STAFF REPORT
COMMUNITY DEVELOPMENT DEPARTMENT

HEARING DATE: December 2, 2021
 TO: Planning & Zoning Commission
 FROM: Sonya Allen, Associate Planner
 208-884-5533
 SUBJECT: H-2021-0075
 Rackham East – AZ, PP
 Eagle View Apartments – CUP, ALT
 LOCATION: South side of I-84, ¼ mile east of S. Eagle Rd., in the south ½ of Section 16, T.3N., R.1E.

B. Preliminary Plat (date: 10/25/2021)

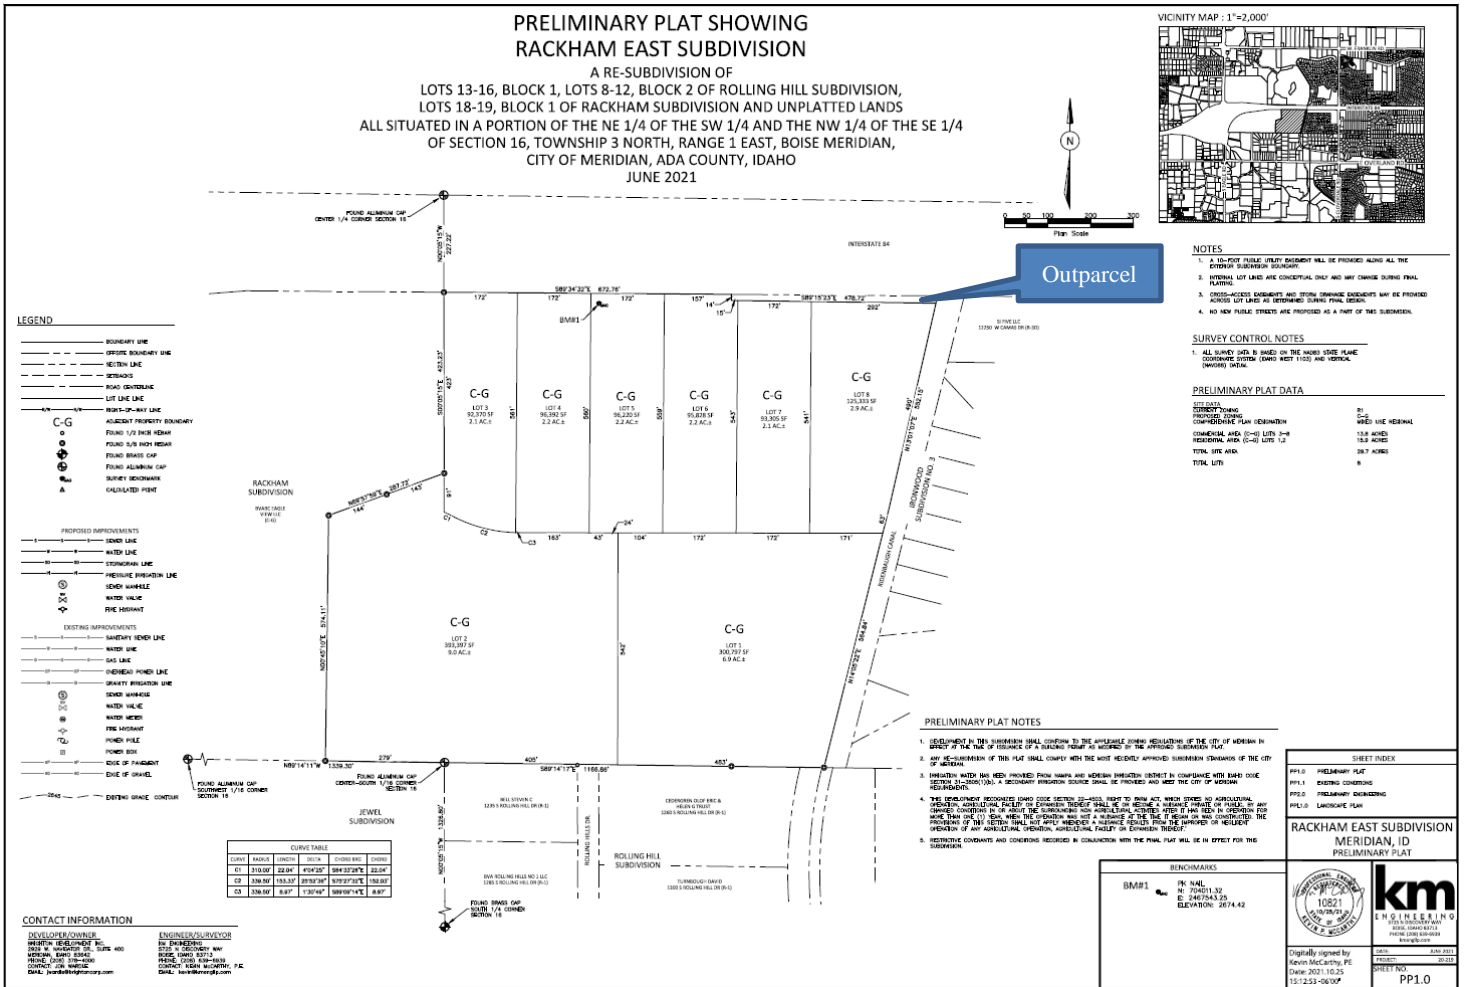
A 50-foot wide street buffer is required on Lots 3-6 along the north boundary of the site adjacent to I-84 per UDC [Table 11-2B-3](#), landscaped per the standards listed in UDC [11-3B-7C](#). The buffer depicted on the landscape plan complies with this standard. The street buffer is required to be maintained by the property owner or business owners' association per UDC [11-3B-7C.2b](#) and should be depicted on the plat in a common lot or permanent dedicated buffer.

Landscaping is required adjacent to the pathway proposed along the northern boundary of the site in accord with the standards listed in UDC [11-3B-12C](#). **A 5-foot wide landscape strip is required on both sides of the pathway planted with a mix of trees, shrubs, lawn and/or other vegetative ground cover.**

3. The landscape plan submitted with the final plat shall be revised as follows:
 - a. Depict a pathway within the street buffer along I-84 as shown on the CUP landscape plan with landscaping in accord with the standards listed in UDC 11-3B-12C. *A 5-foot wide landscape strip is required on both sides of the pathway planted with a mix of trees, shrubs, lawn and/or other vegetative ground cover.*

D. Conceptual Development Plan

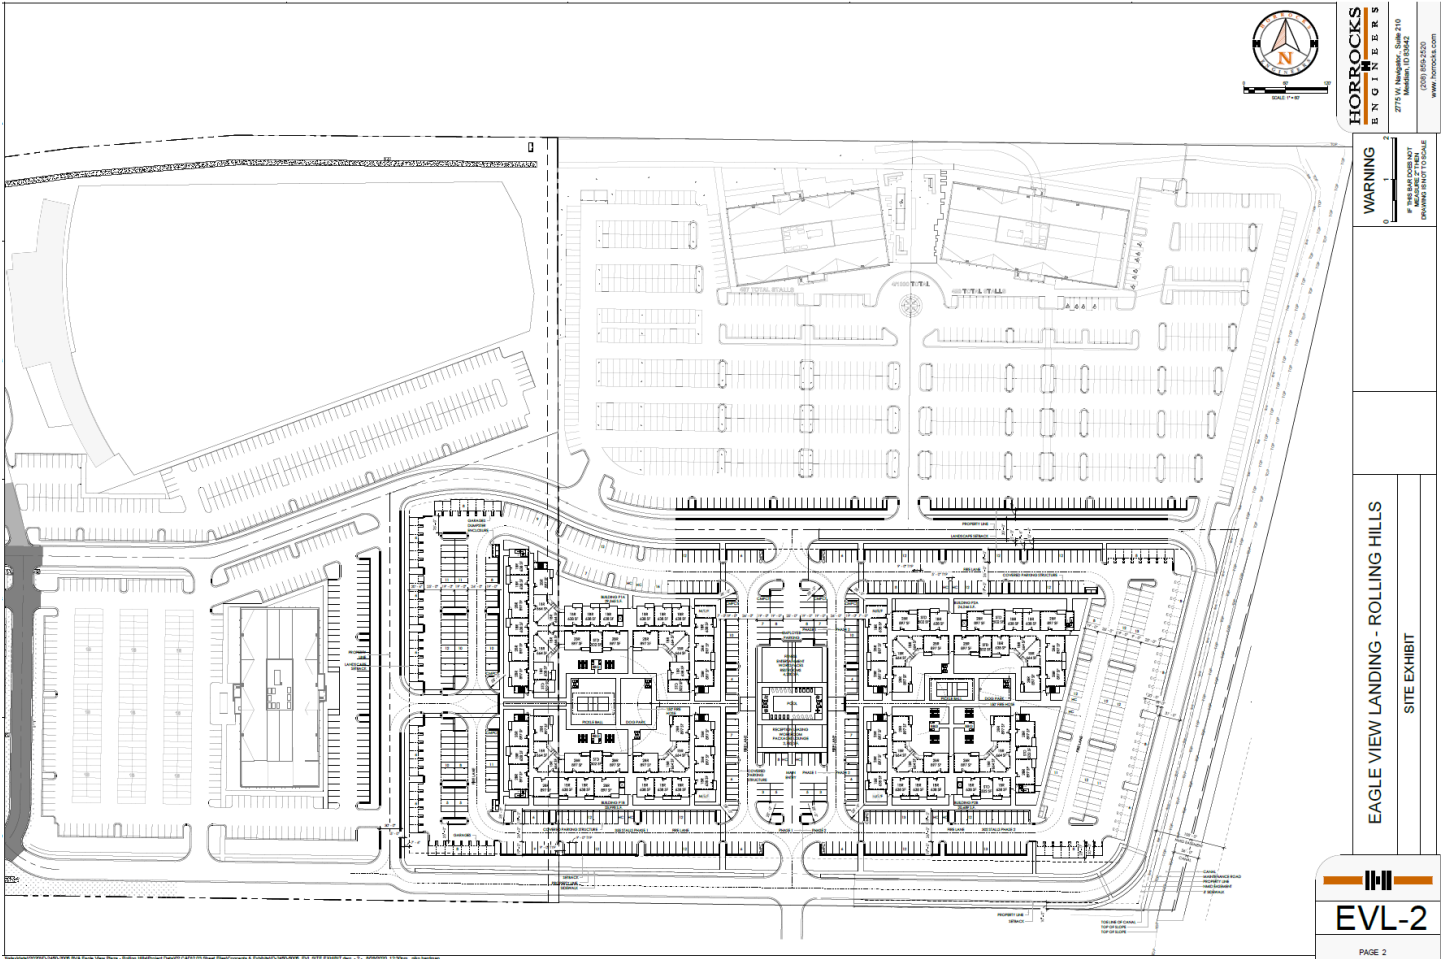
The conceptual development plan depicts a common area between the two office buildings that appears to meet this guideline; more details should be submitted on a site plan submitted for development of these buildings that comply with this guideline.

An outdoor gathering area is depicted on the conceptual development plan between the two office buildings on the northern portion of the site. Details should be submitted with development of these buildings that demonstrate compliance with this guideline.

The proposed conceptual development plan depicts a plaza/gathering area between the two office buildings on the northern portion of the site. A pedestrian circulation network, which will connect to the larger 90-acre Eagle View/Rackham development to the west, is proposed around the perimeter of the overall development as well as throughout the site that provide pedestrian connections to the multi-family development, office, retail, restaurant and hospitality uses within the development.

The conceptual development plan depicts a pathway within the street buffer along I-84. The pedestrian plan included in Section VII.H depicts internal pedestrian walkways throughout

- b. The two (2) office buildings proposed on the northern portion of the site shall be arranged to create some form of common, usable gathering area, such as a plaza or green space in accord with the mixed-use guidelines in the [Comprehensive Plan](#) (see pg. 3-13).

- c. Provide a pedestrian pathway within the street buffer along I-84 as depicted on the conceptual development plan with landscaping along the pathway as set forth in UDC [11-3B-12C](#). Also provide internal pedestrian walkways throughout the site for interconnectivity; where pedestrian walkways cross vehicular use areas they shall be distinguished through the use of pavers, colored or scored concrete, or bricks as set forth in UDC [11-3A-19B.4](#).

F. Landscape Plan – Conditional Use Permit (dated: 6/3/21)

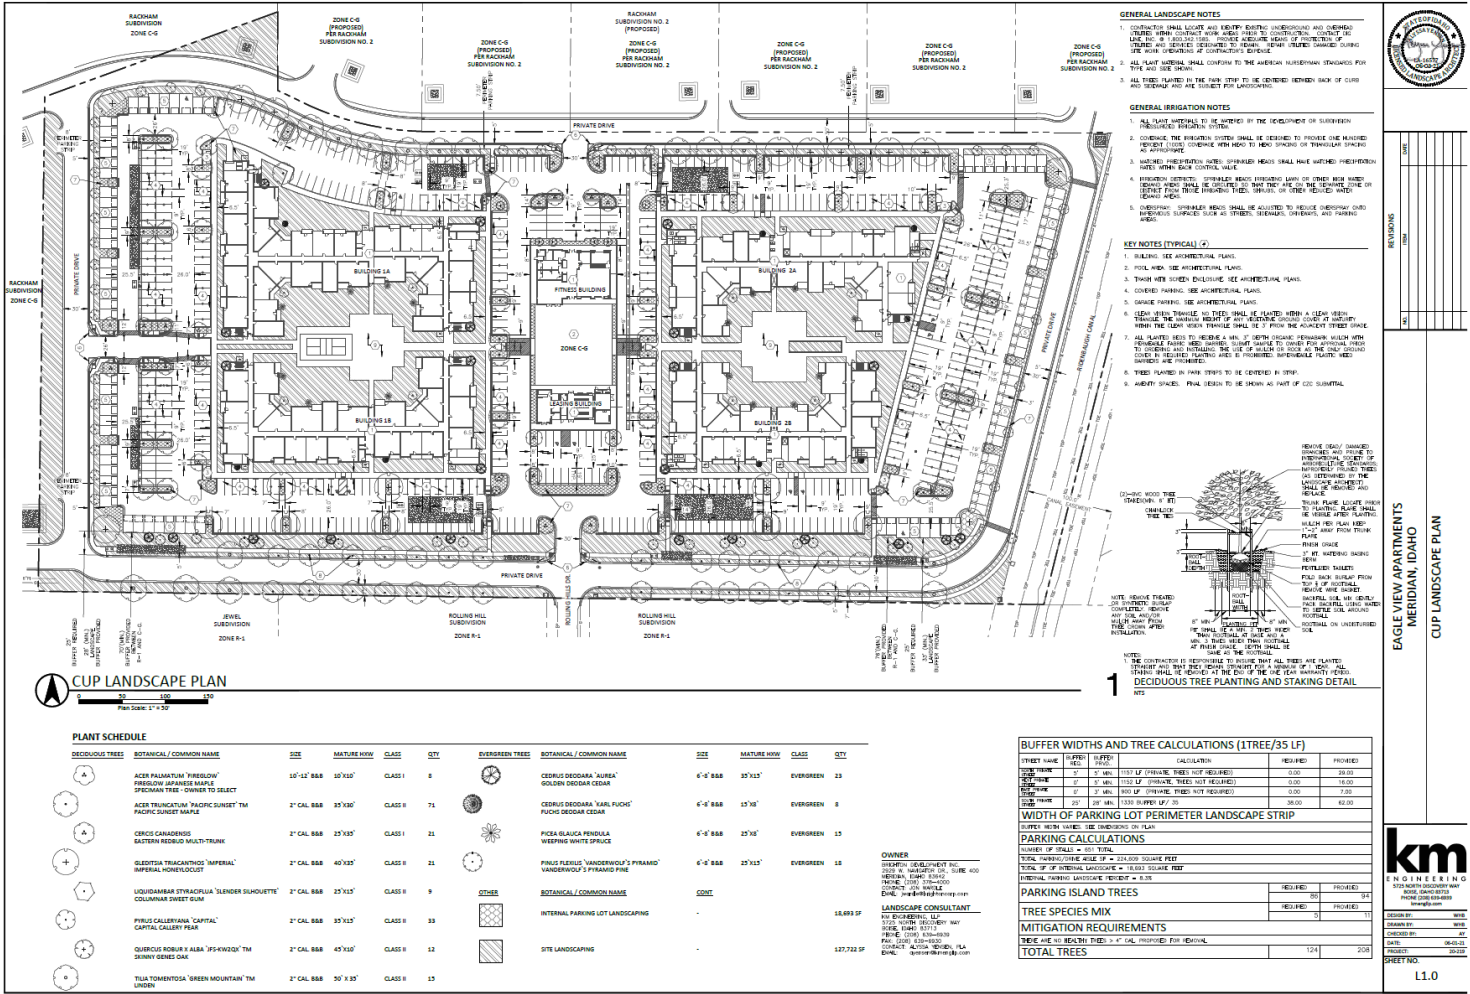
All fencing is required to comply with the standards listed in UDC 11-3A-7. Fencing is not depicted on the landscape plan; however, a 6-foot tall open vision wrought iron fence is proposed along the Ridenbaugh Canal to preserve public safety if Council approves a waiver to allow it to remain open and not be piped.

A minimum 25-foot wide buffer to residential uses is required with development along the southern boundary of the site per UDC Table 11-2B-3, landscaped per the standards in UDC 11-3B-9C, which requires a mix of evergreen and deciduous trees, shrubs, lawn, or other vegetative ground cover. **The buffer depicted on the landscape plan needs to be widened and additional landscaping depicted in accord with these standards.**

Fencing: No fencing is depicted on the landscape plan for this development. A 6-foot tall open vision wrought iron fence is proposed along the Ridenbaugh canal to preserve public safety if Council approves a waiver to allow the canal to remain open and not be piped.

As an added buffer to the two adjacent rural residential properties to the south in Rolling Hill Subdivision, Staff recommends a 6-foot tall sight obscuring fence or wall is constructed along the southern boundary of the site.

- e. Depict a 6-foot tall sight obscuring fence or wall along the southern boundary of the site as an added buffer to the rural residential properties to the south in Rolling Hill Subdivision.
